**Document Description : Addendum No.01 - Twin Falls SP Cabin Rehabilitation**

**ADDENDUM NO. 01**  
**REQUEST FOR QUOTATION**  
**West Virginia Division of Natural Resources-Parks & Recreation**  
**ARFQ DNR19\*60 Twin Falls SP Cabin Rehabilitation and Renovation**

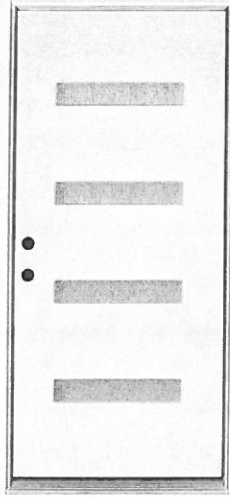
**Vendor Question No. 2:** Please be more specific on style and color. Pricing will range significantly depending on these options.

**Agency Response:** Selected style of Shenandoah cabinetry is the Cottage Collection with a painted finish.
